PIPING SYSTEM: ...
 REFERENCE: B&R DWG: 2148
 MARK NO: 633-(R1) NO REQD

BERGEN-PATERSON PIPESUPPORT CORP.

2	28	20 NOV 63
JOB NO P-66-1262-1.1		
DWG NO 173-1

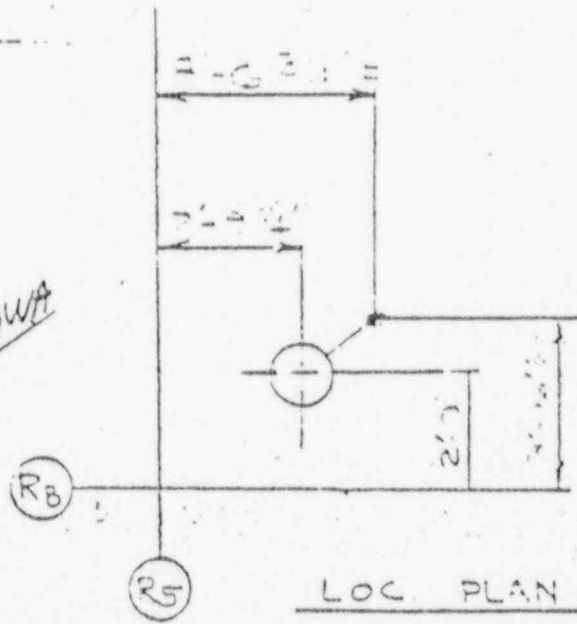
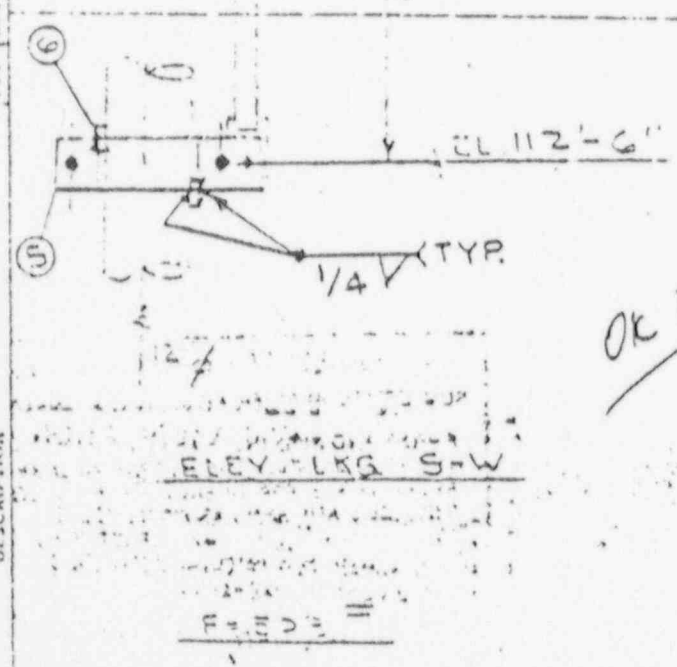
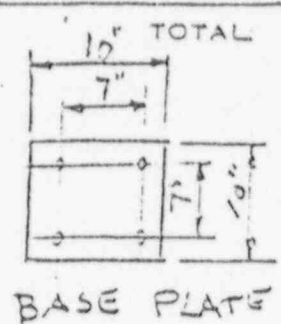
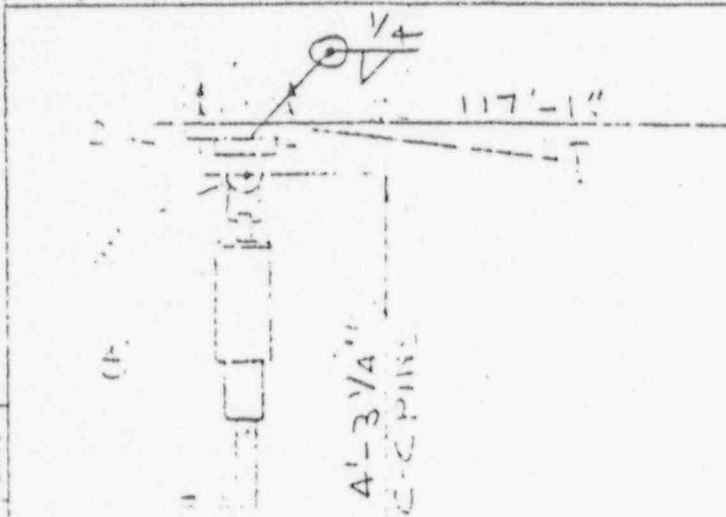
ADDED ITEM #6 & REV'D WELDS
